**A PROBABILISTIC SAFETY ASSESSMENT
PEER REVIEW:
CASE STUDY ON THE USE OF
PROBABILISTIC SAFETY ASSESSMENT
FOR SAFETY DECISIONS**

**A TECHNICAL DOCUMENT ISSUED BY THE
INTERNATIONAL ATOMIC ENERGY AGENCY, VIENNA, 1989**

In this case study the PSA had examined the Shoreham Nuclear Power Station, owned by Long Island Lighting Company, the PSA sponsoring Utility on the North Shore of Long Island, New York. The case study references other PSA literature on peer review which helps put this case study in perspective. One such reference, An Intensive Peer Review for PRA [ref 4] in fact contains a fully-documented case study of a peer review for a level 3 PSA. The reader is encouraged to refer to this Nuclear Safety Analysis Center report, available through the Electric Power Research Institute as the NSAC-67 report.

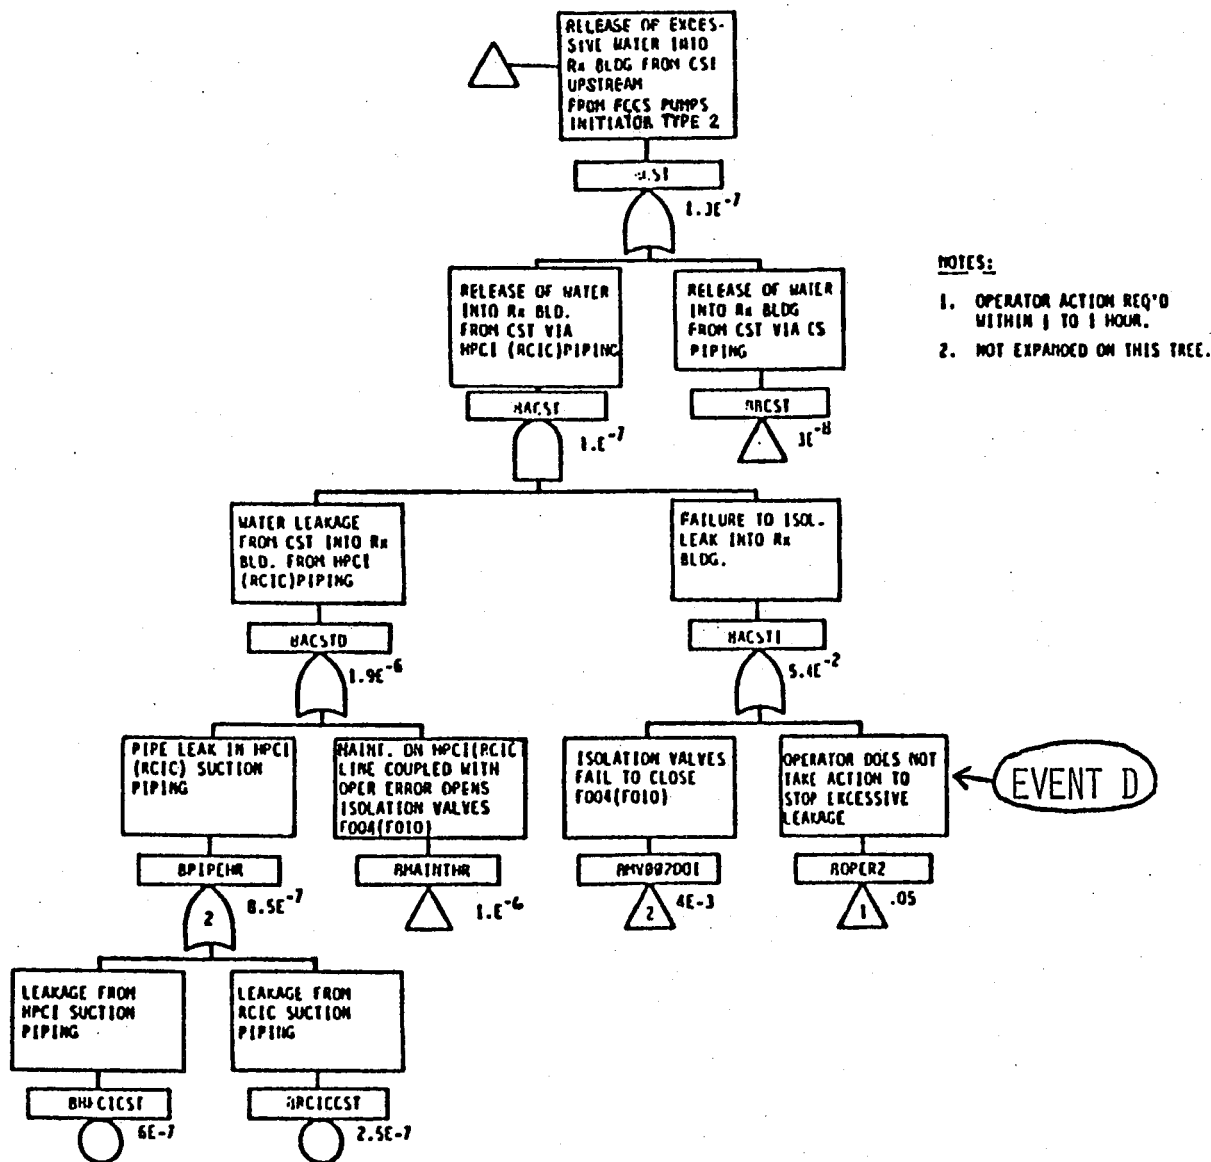
Also, one can see from the event tree in Figure 1 that the PSA Contractor assigned a probability of 0.12 to failing to restore the condensate system. Considering the level of stress involved, a probability of 0.25 or higher could be a more reasonable estimate.

Examining the event tree in Figure 1, one can see that the PSA Contractor calculated a frequency of $4.8 \text{ E-}7$ per reactor year for flooding to the six foot level (T2 initiator) and $5.8 \text{ E-}8$ per reactor year for class I core vulnerable accident.

However, following the arguments given above, the estimate for the T2 initiator could be as high as $1.0 \text{ E-}3$ per reactor year for flooding to the six foot level and $5 \text{ E-}4$ per reactor year (or higher) for class I core vulnerable accident - factors of 2000 difference! These class I accident figures are for the core vulnerable states to be reached: the core melt frequency would be somewhat smaller depending on an analysis that the review team did not do.

A portion of the PSA Contractor's reply to the peer review concerning internal flooding is given in Appendix B of this case study. The PSA Contractor recomputed the core melt frequency due to an internal flooding accident and estimated the fractional contribution of this accident to the total core melt frequency as 3%.

FIG. 2. A typical fault tree development for elevation B flood Initiator type 2 [ref 1].

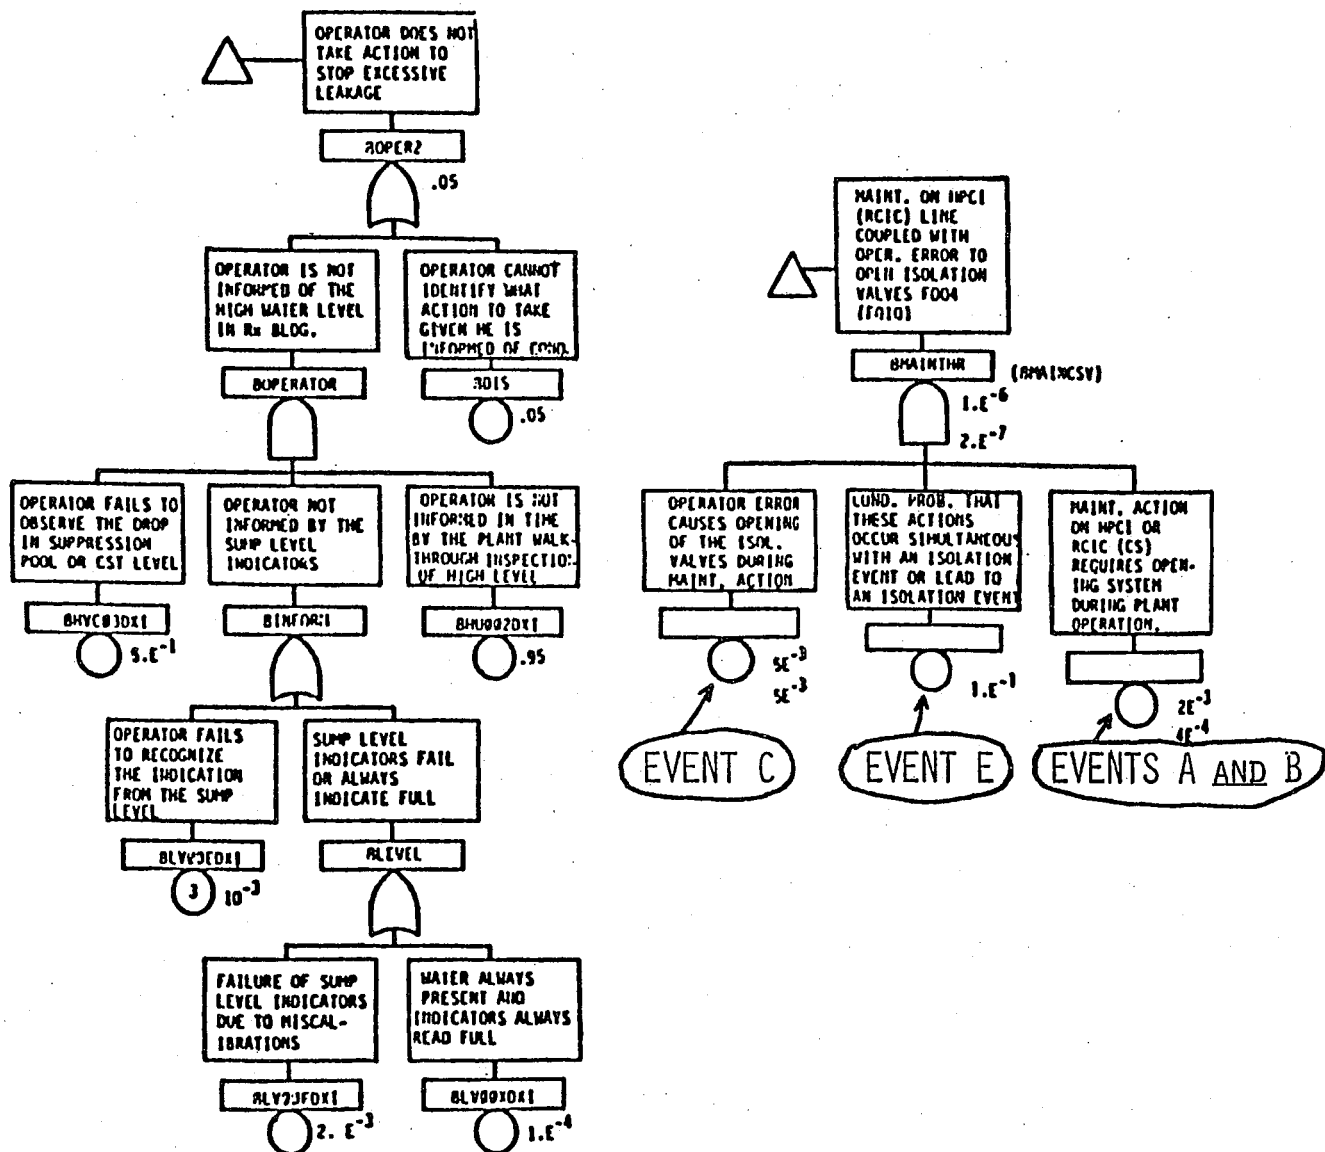
- The approach used by the PSA Contractor in quantification of these sequences does not produce units with accident frequency. One key event in the flooding sequence is the operator inadvertently opening a valve during maintenance. The probability estimate for this event is given on a per maintenance act basis. The PSA Contractor's calculations did not reflect this, which leads to a factor of about 100 in underestimating the internal flood frequency.
- The PSA Contractor used human probability estimates from Swain and Guttman's work, [ref 7], that do not reflect a highly stressful situation. The reviewers believed that a highly stressful situation does exist when internal flooding occurs and that all calculations should reflect this.

As described above, event C is the initiating event which causes flooding. The occurrence of events A and B defines a vulnerable system state that permits event C to initiate flooding when event C occurs. Furthermore, the occurrence of events A and B and C defines another vulnerable system that permits event E to initiate the accident sequence when event E occurs. Because event C is an initiating event, we must compute the frequency of occurrence of this event.

Hence the units on event A should be the expected number of on-line maintenances per year, (i.e., frequency), not system unavailability as computed by the PSA Contractor. Computation with system unavailability results in an accident frequency about 100 times smaller than with the expected number of maintenance acts per year.

The peer reviewers recommended that the PSA Contractor recompute the internal flood frequency considering event A be given in units of frequency. Furthermore, because the internal flooding sequence is dominated by a chain of human error events, the reviewers recommended that experts in human factors carefully analyze and recompute these accident frequencies associated with
